SUBJECT: Forwards responses to Round 2 questions. Remaining responses will be completed by 810904. Responses & applicable FSAR changes will be incorporated into Amend 19 of FSAR.

Subject: SUPPLY SYSTEM NUCLEAR PROJECT NO. 2  
RESPONSES TO ROUND TWO QUESTIONS  
REACTOR SYSTEMS BRANCH

WNP-2

FIGURE  
5.2-5

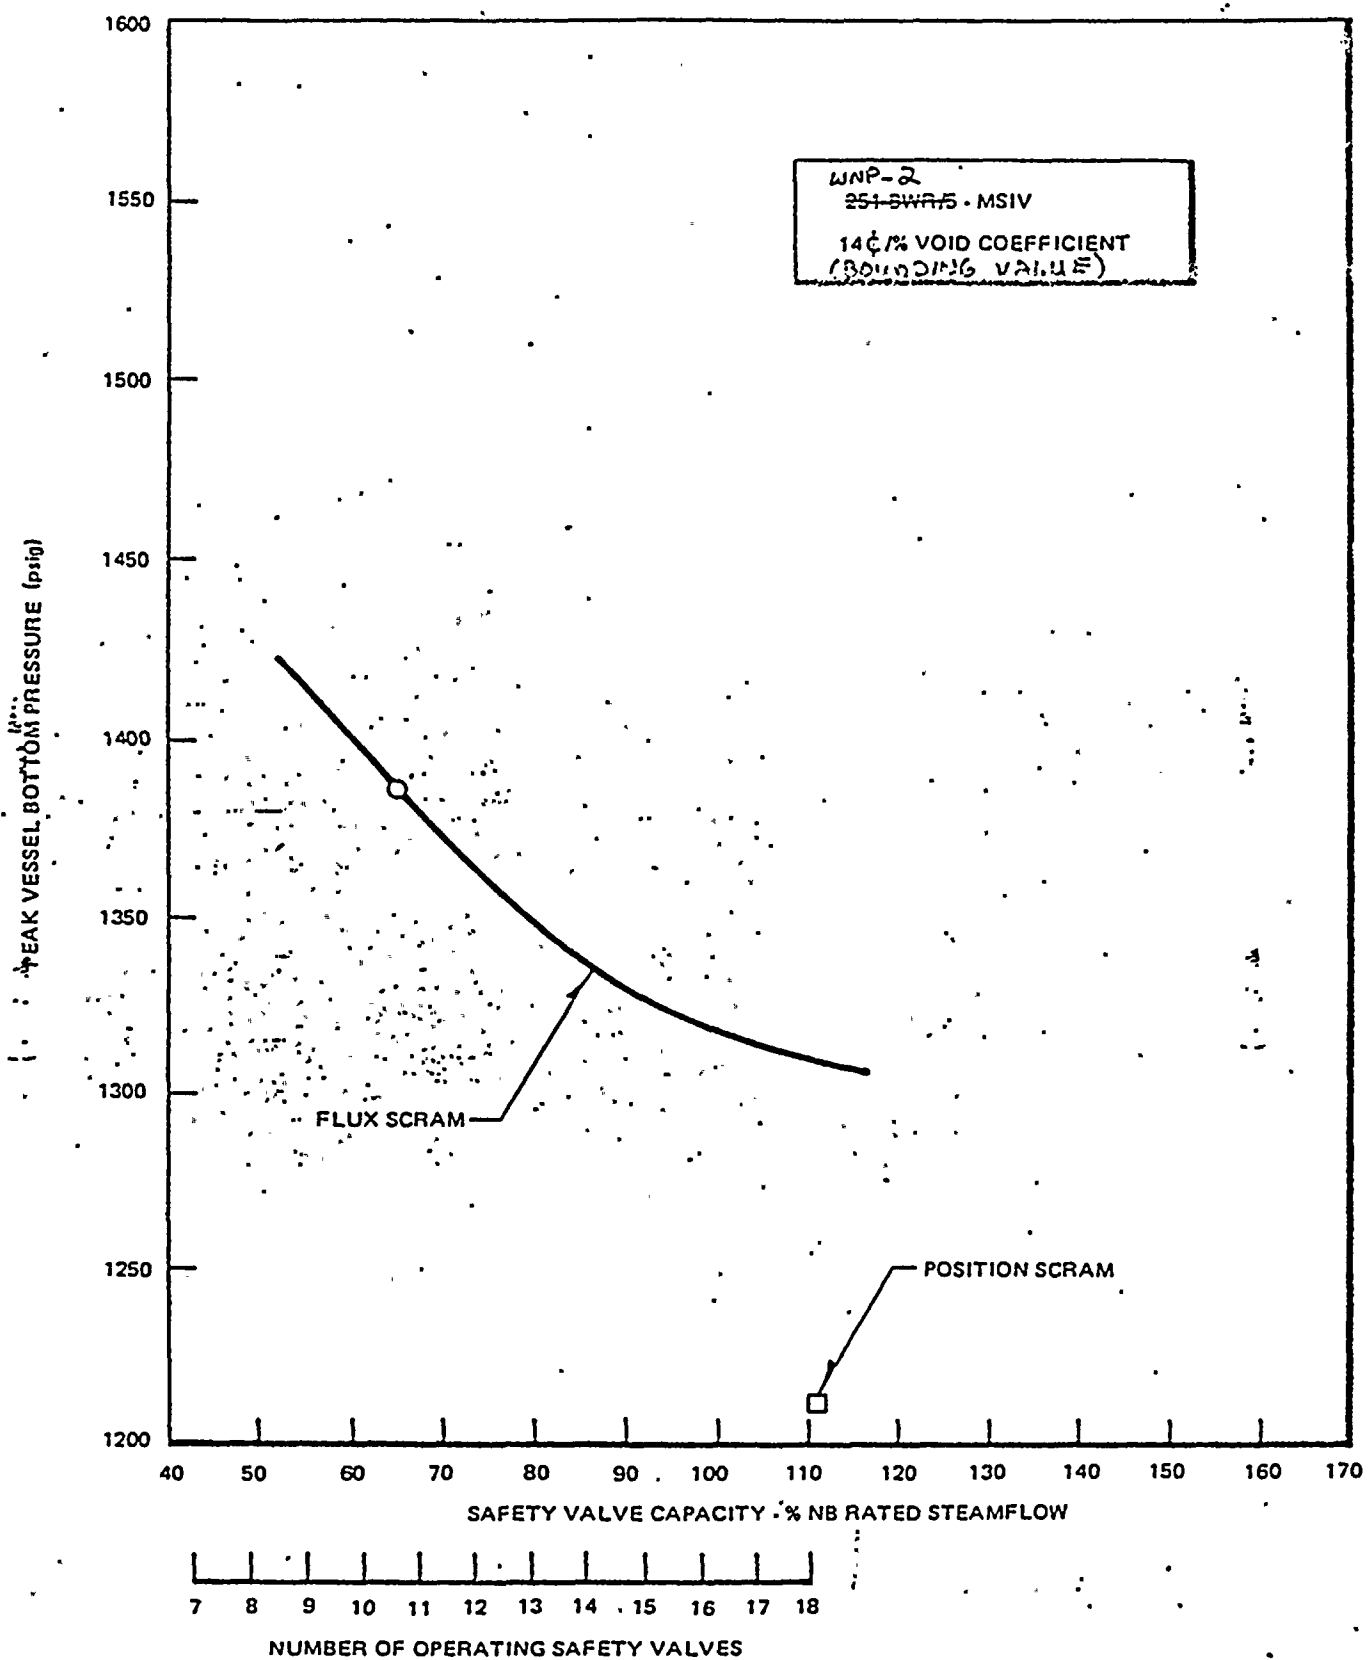
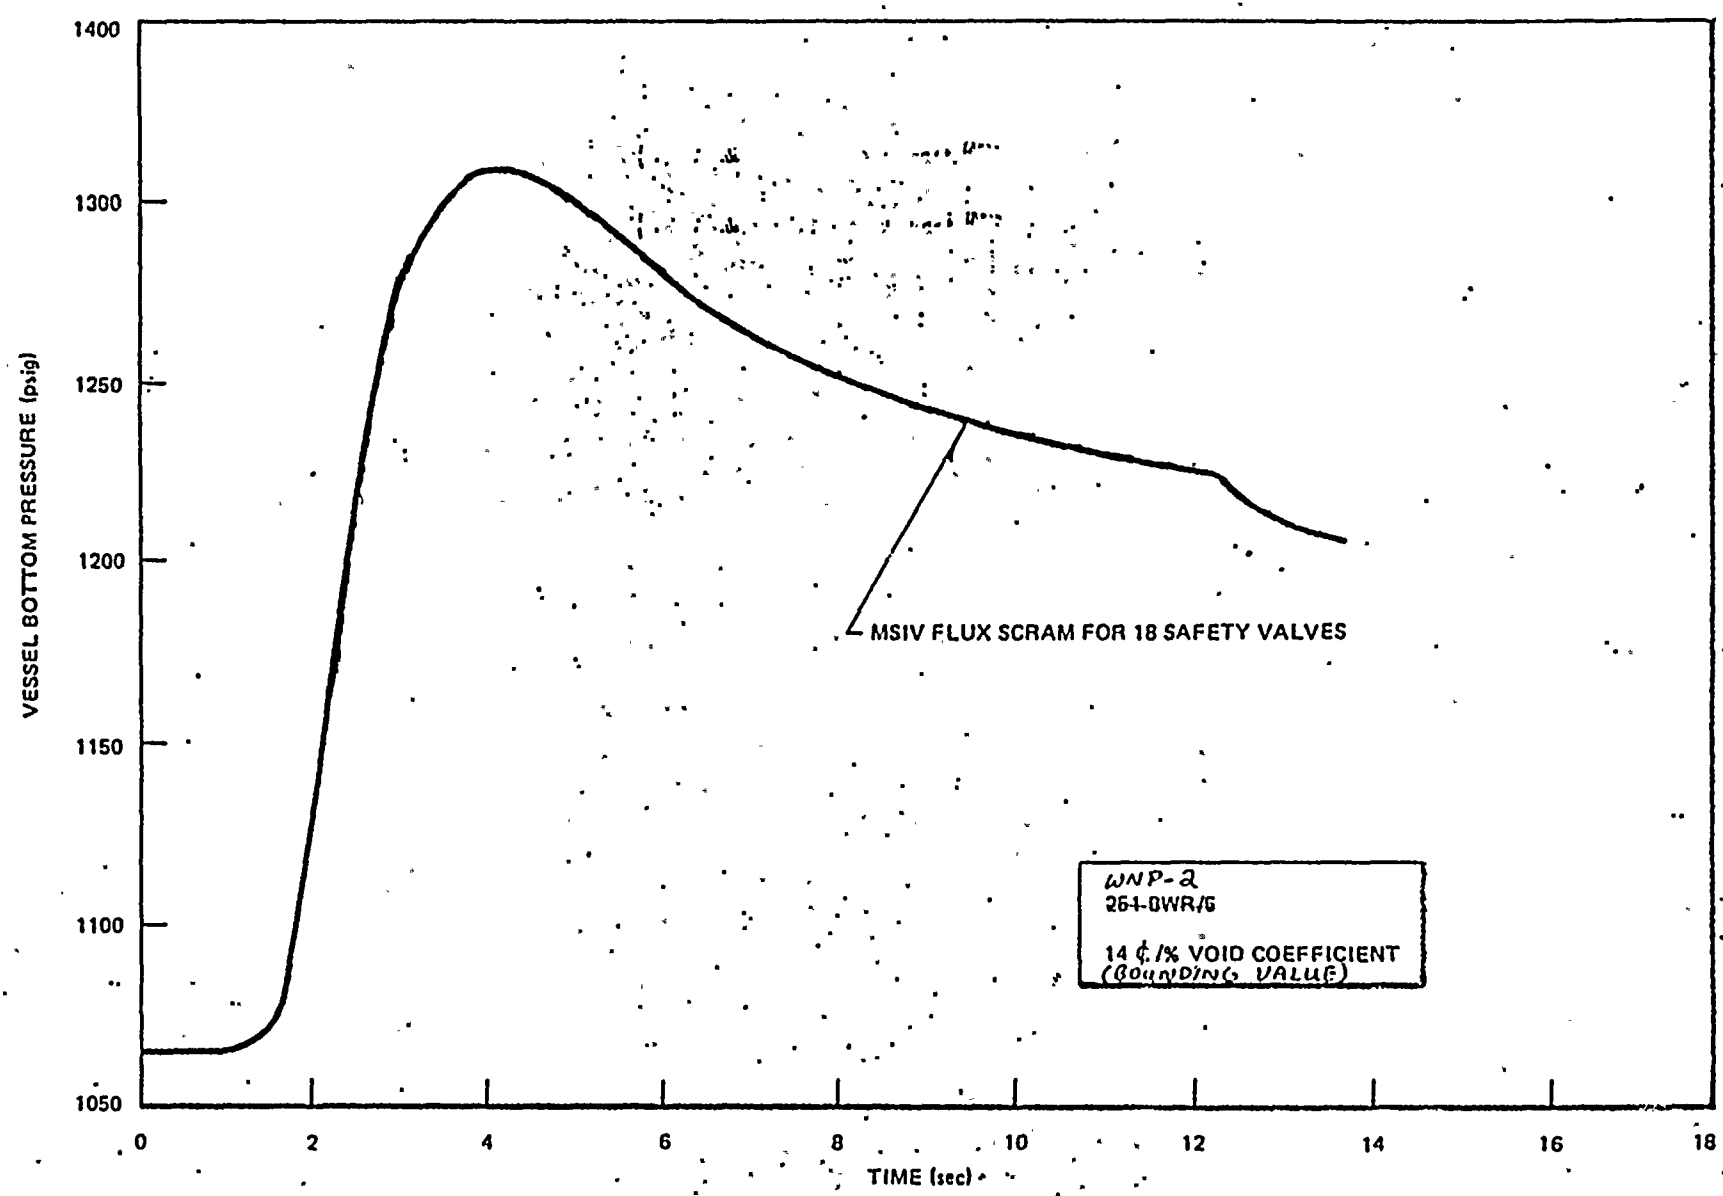
The notations, "251 BWR/5-MSIV, 140% Void Coefficient" on Figures 5.2-4 and 5.2-5 indicate that these figures may be generic and not specifically for WNP-2. Confirm that these figures are applicable to WNP-2. If these curves are not applicable to WNP-2, complete the necessary analyses to provide data similar to that now presented on Figures 5.2-4 and 5.2-5.

Figures 5.2-4 and 5.2-5 are not generic but do apply to WNP-2 and several other BWR/5 projects. The void reactivity coefficient of 140% is a bounding value which is conservatively applied to the overpressure protection analysis. These figures have been changed to reflect their applicability to WNP-2.\*
